**Submittal**

**Job:** 1402  
Munjoy Heights  
Sheridan St. Extension  
Portland, ME 04101

**Submittal Title:** Retaining Wall Product Data and Shop Drawings

**Submittal Review**

**WALL CROSS SECTION**  
NOT TO SCALE

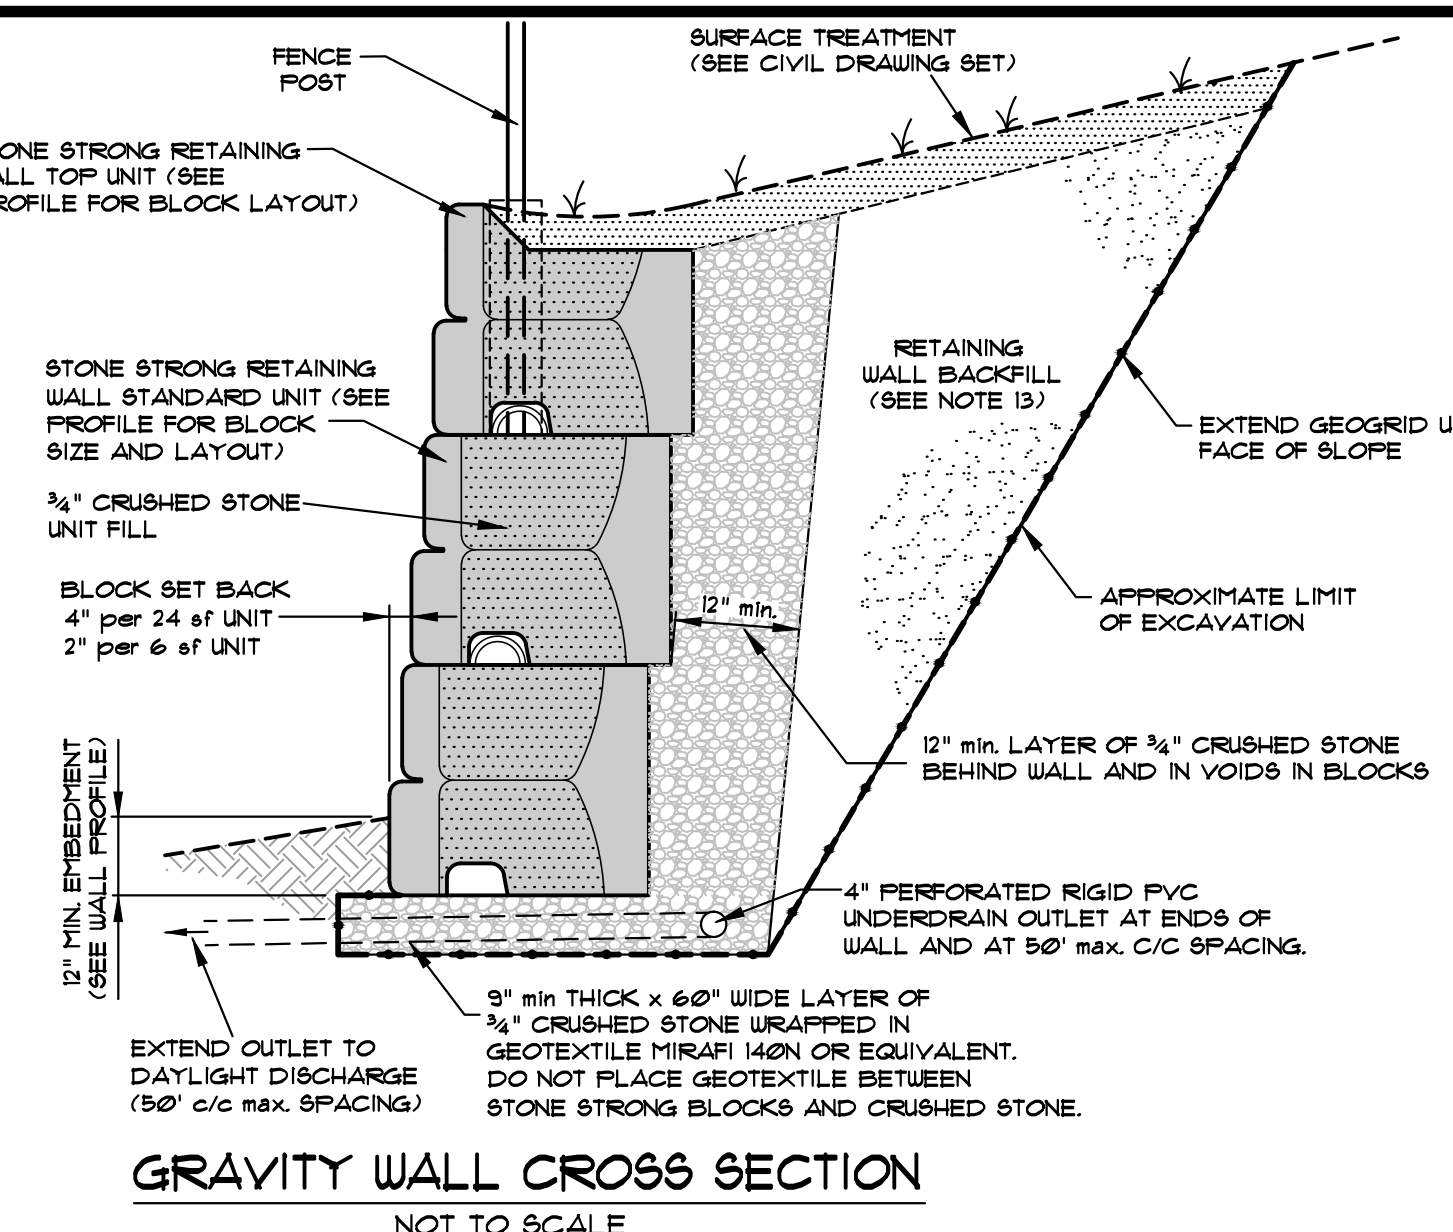
- 5) The Contractor shall coordinate the location and elevation of the secondary underdrain within the Wall Cross-Section with Acorn Engineering.
- 6) For proposed site grading the Contractor shall refer to Acorn Engineering's Grading, Drainage & Erosion Control Plan, Issued for Construction, dated 2/21/14.
- 7) Wall Cross-Section Detail – Note: Retaining Wall Backfill (See Note 13) would appear to be mis-numbered and apply to Note 24.
- 8) Inspection of the retaining walls during construction is not provided by Acorn Engineering. The Contractor shall coordinate with Summit Geoengineering Services for their inspections services.
